1st Read Manual Language for Hybrids Phase 1a – Manual 14D and Manual 10

Darrell Frogg
Lead Engineer, Generation Department
PJM System Operations Subcommittee
July 7, 2022

Manual 10: Pre-Scheduling Operations, Revision XX
Manual 14-D: Generator Operational Requirements Revisions, Revision XX

Section 4.2.3 Metering for Individual Generators

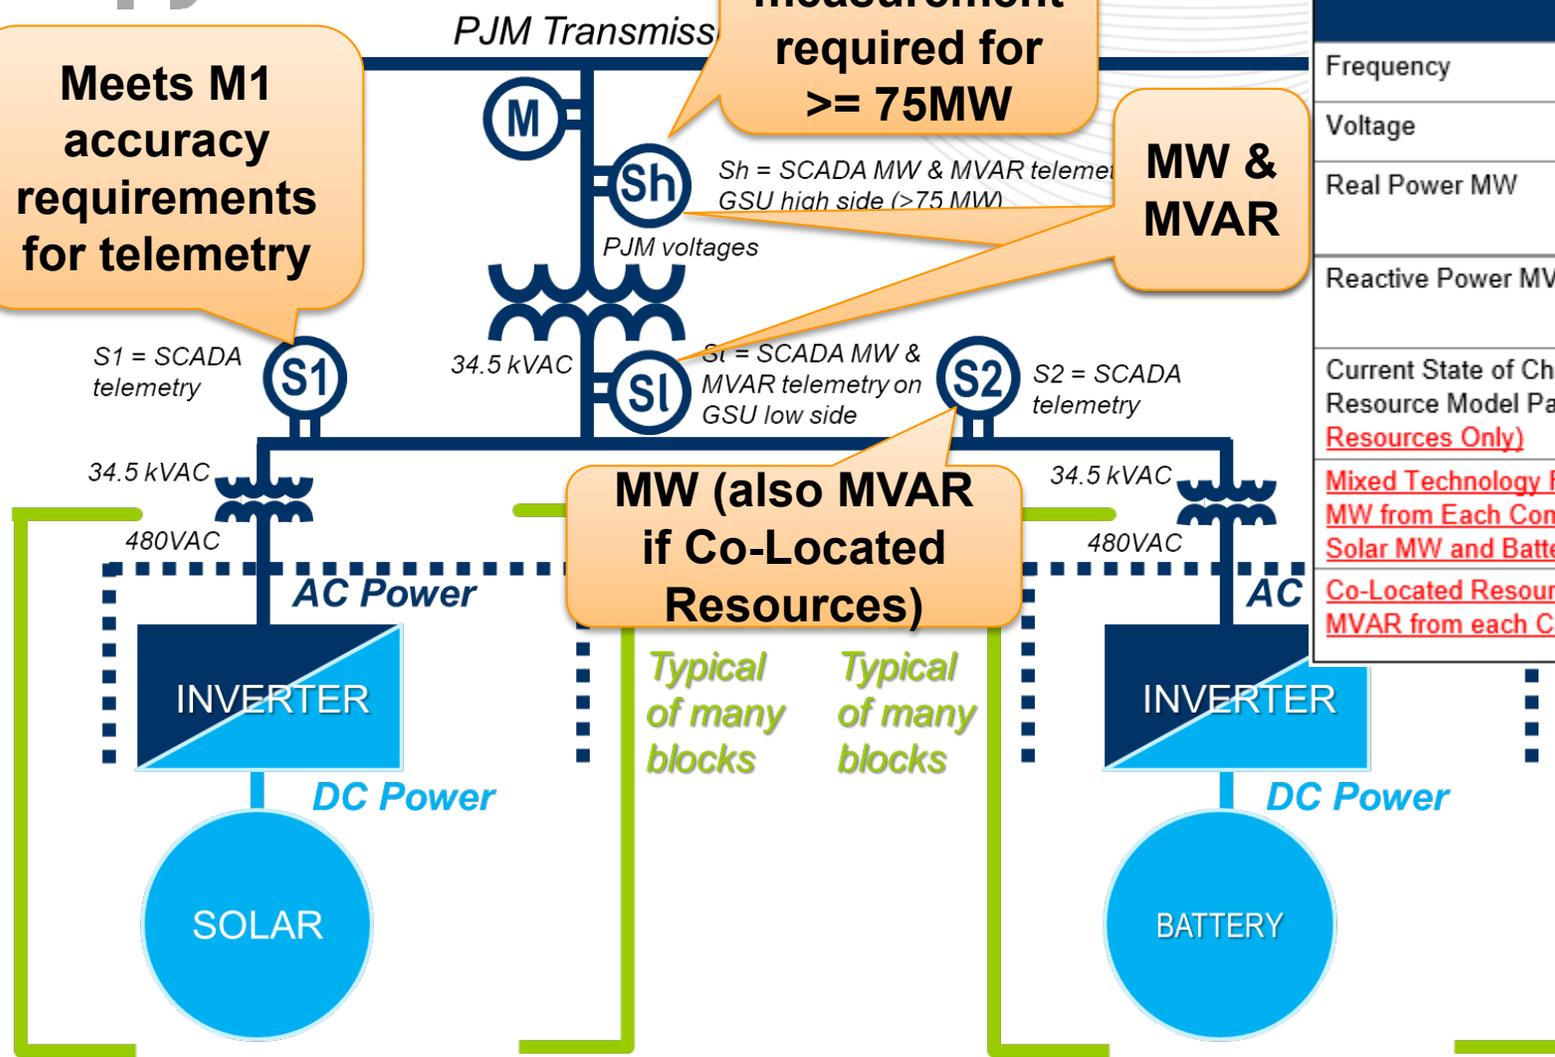
Meets M1 accuracy requirements for telemetry

High-Side measurement required for $\geq 75\text{MW}$

MW & MVAR

MW (also MVAR if Co-Located Resources)

Exhibit 15: Example of inverter-based AC-coupled open-loop Hybrid Resource with 100 MW solar and 40 MW battery.

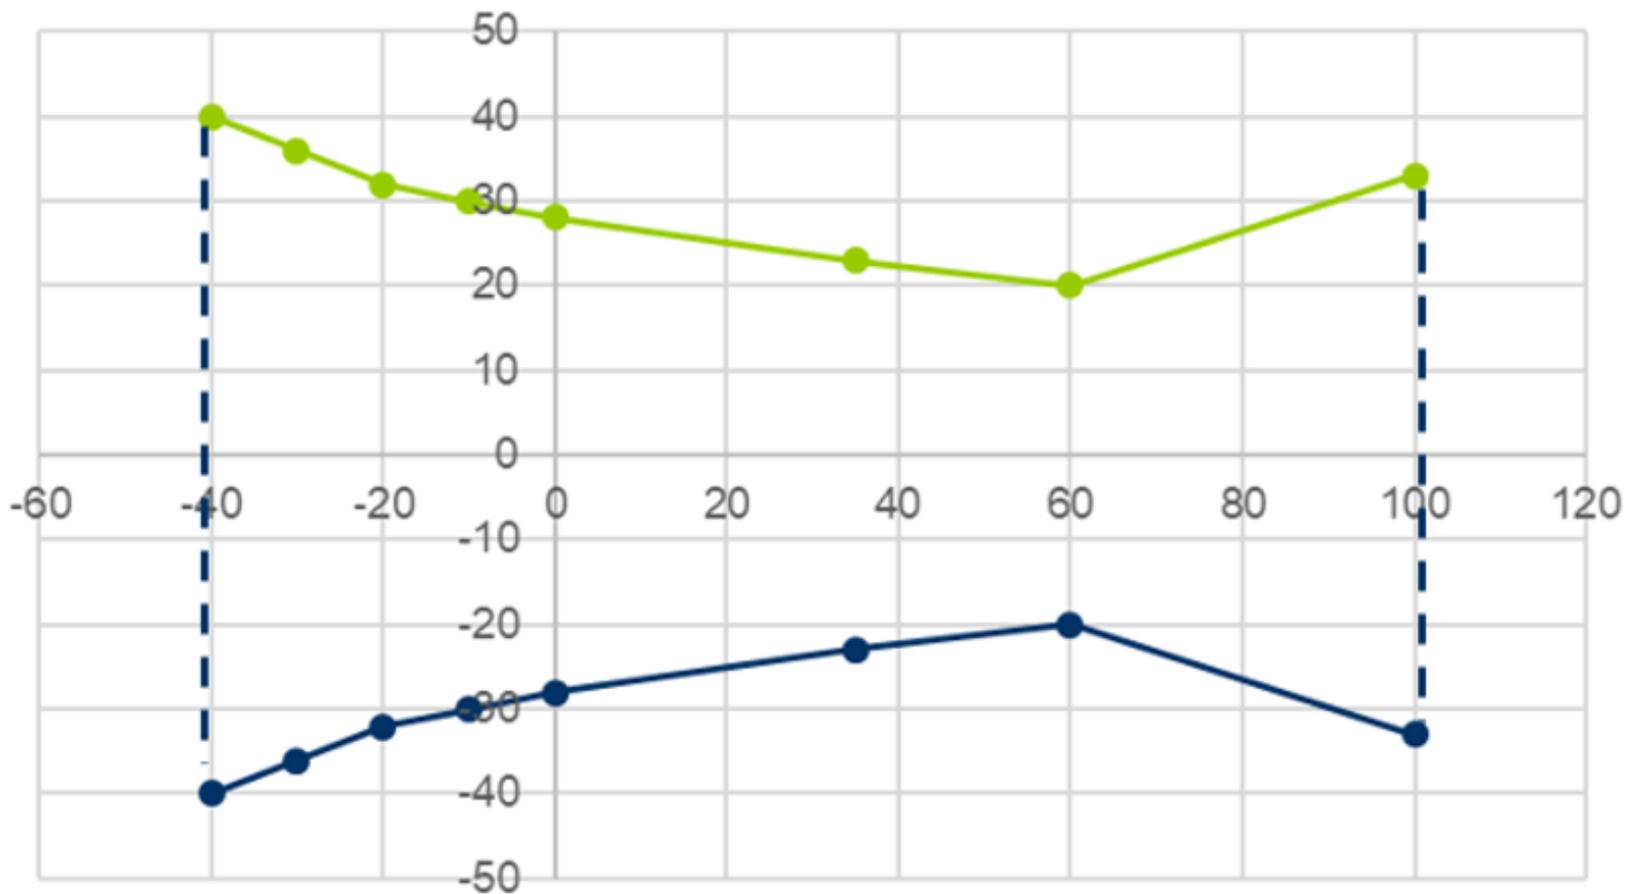
An AC-coupled Hybrid Resource has two (sets of) electrical machines (i.e., inverters), and so shows a D-curve that reflects conservative conditions.

In particular, for the solar to feed the battery, both the solar inverters and the battery inverters need to do an AC power conversion. This leaves less inverter capability available for reactive.

Figure 16: Example of inverter-based DC-coupled open-loop solar-storage Hybrid Resource with 100 MW solar and 100 MW battery.

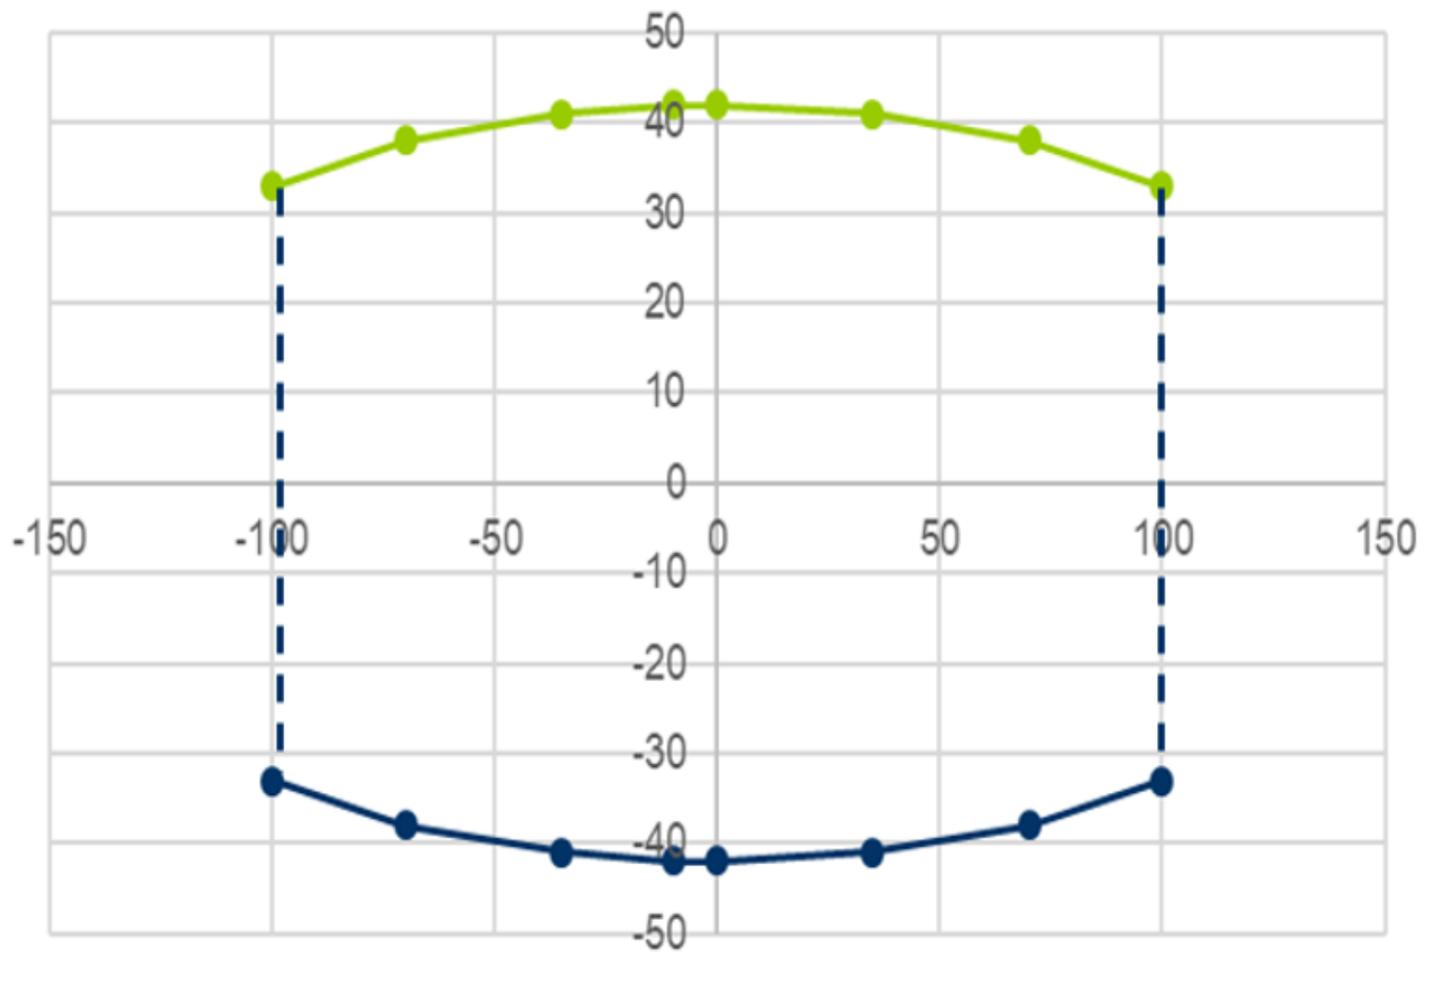
A DC-coupled Hybrid Resource has a single (set) of electrical machines (i.e., inverters), and so shows a more typical D-curve.

In particular: the solar would feed the battery directly, without needing AC power conversion. This leaves more inverter capability available for reactive.
